**CITY OF SEATTLE
ANALYSIS AND DECISION OF THE DIRECTOR
OF THE DEPARTMENT OF PLANNING AND DEVELOPMENT**

Project Number: 3012205

Applicant: Ginger Garff of Johnston Architects for Greenfire LLC

Address: 2034 NW 56th St

The fourth scheme (Alternative D, the preferred alternative) was added by the applicant at

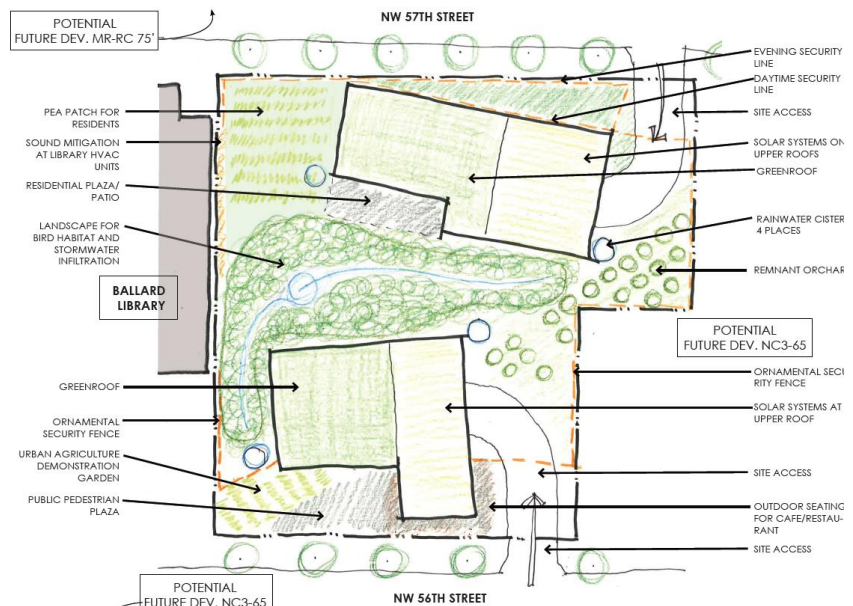
- The canted building orientation in Alternative 4 is good for reducing glare, but could result in less light for the large number of north-facing units in the residential building. The east-facing office spaces will receive morning glare.

At the Early Design Guidance Meeting, the Board noted that the proposed Alternative 4 massing will present a street frontage that doesn’t respond to nearby streetscape development at the property line, but this could be an interesting break in the fabric. The applicant should provide more information at the Recommendation stage of review indicating how the proposed streetscape design would create positive spatial characteristics and relate to the nearby streetscape.
